Construction Division
Additions & Alteration Charges Approval Form

Company Name:	MRMLLP	Site	Gulmohar Residency
Name of the customer	N. Greenivas		
Villa/ Flat No.	D-104.		
Sl.No	Description	Amount	
1	Total extra Charges	50656	
2	Total refundable amount	1920	
3	Net amount to be charges (if any)	48736	
4	Net amount to be refunded (if any)	—	
Remarks : Extra charges .			
fourty Eight thousand . Seven hundred thirty Six Rupees only .			
Approved by Project Manager		Approved by Design Team	Approved by MD
Date 01-03-2024		Date	Date
Sign: @king		Sign:	Sign:

GULMOHAR RESIDENCY

Details of Additions & Alterations

Description	Direction	Owners & Developers	Date	Promoted by
WORKING PLAN-1660 Sft - B2 TYPE		Modi Realty Mallapur LLP Project Name & Phase Gulmohar Residency	25/09/2020 Prepared By Jayaprada Approved By Soham Modi Scale N T S	Modi Properties Pvt Ltd Phone: +91-40-66335551

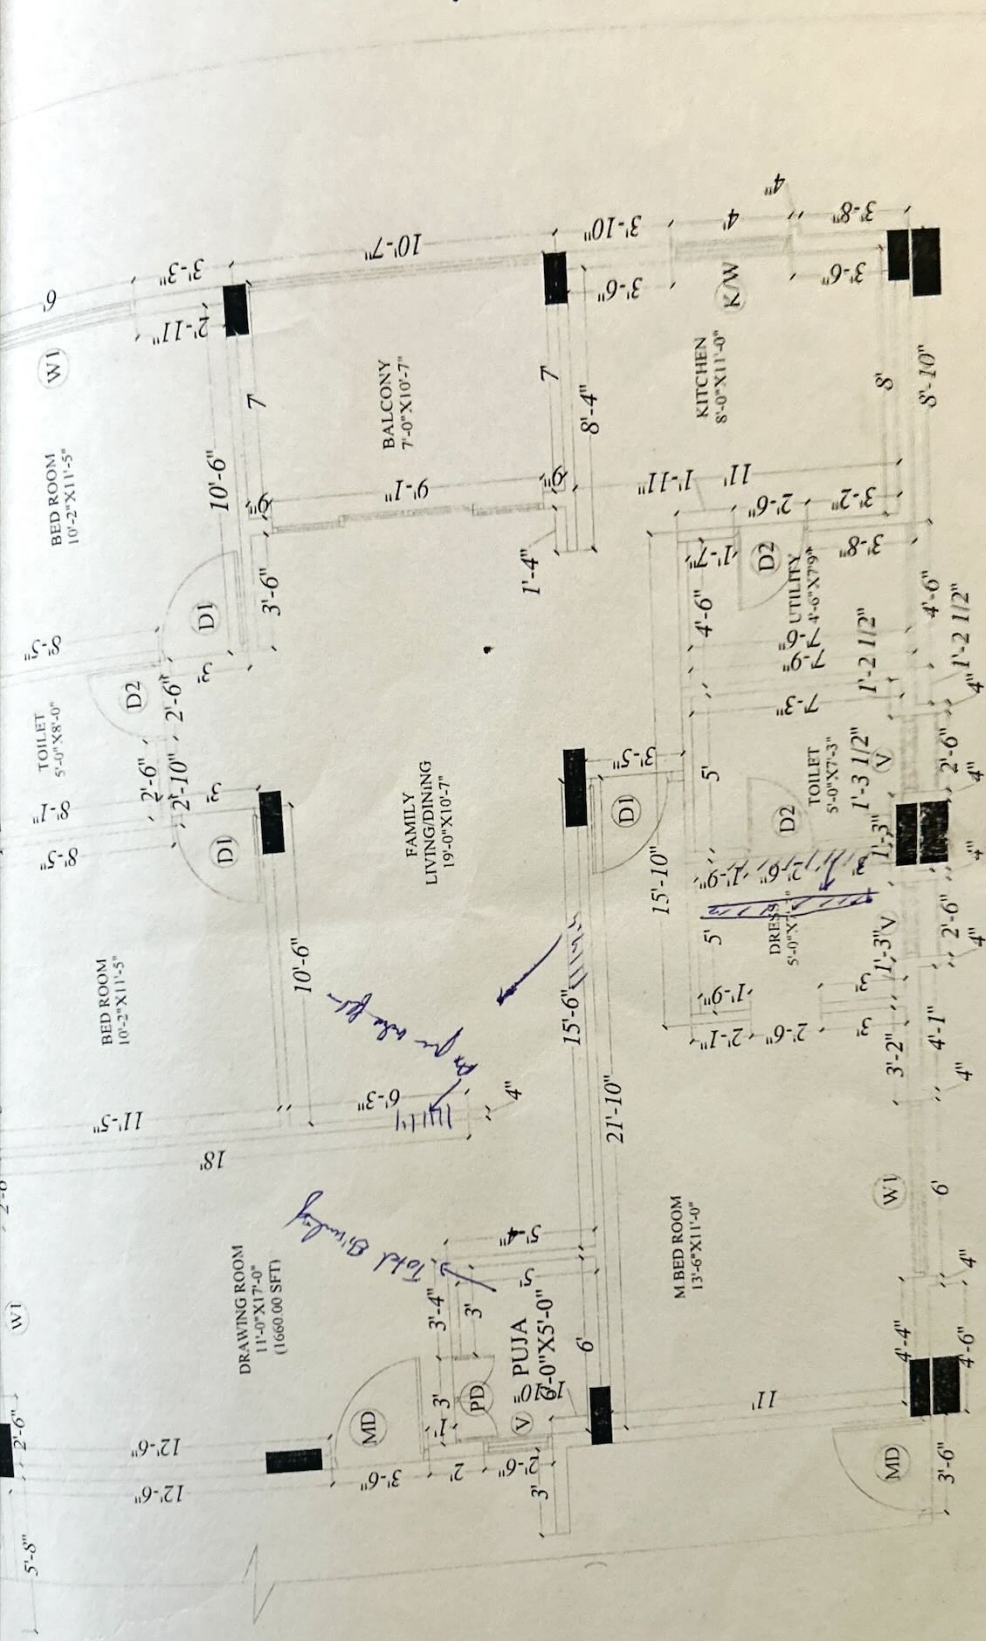
Other Changes:

- 1) Puja Room not required.
- 2) 6'3" wall not required.
- 3) Bath room Size has. to be increased to ~~xxxx~~.
- 4) As mentioned in Plan.
need few extra switch boards.

Description	Direction	Owners & Developers :		Date :	Promoted by	
		Modi Reality Mallapur LLP		Prepared By :	Modi Properties Pvt Ltd	
		Project Name & Phase :		Approved By :	Jayapradha	
		Gulmohar Residency		Scale :	Soham Modi	
				N.T.S		
ELECTRICAL PLAN -B2 TYPE-1660 sft				Phone: +91-40-66335551

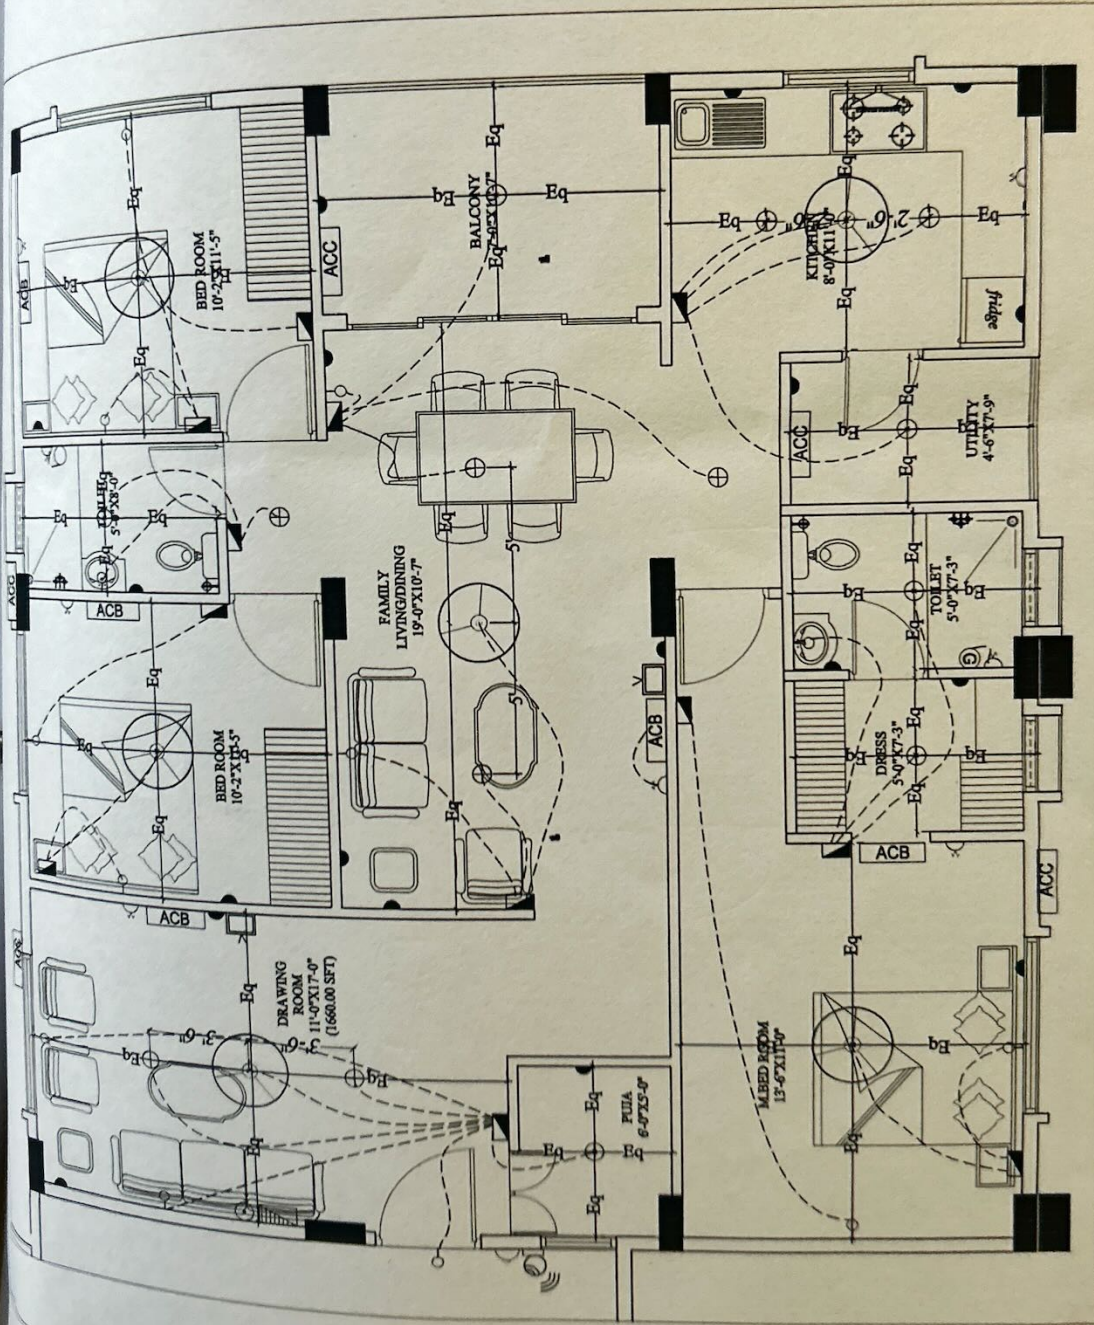
Changes in electrical points: (mark on plan)
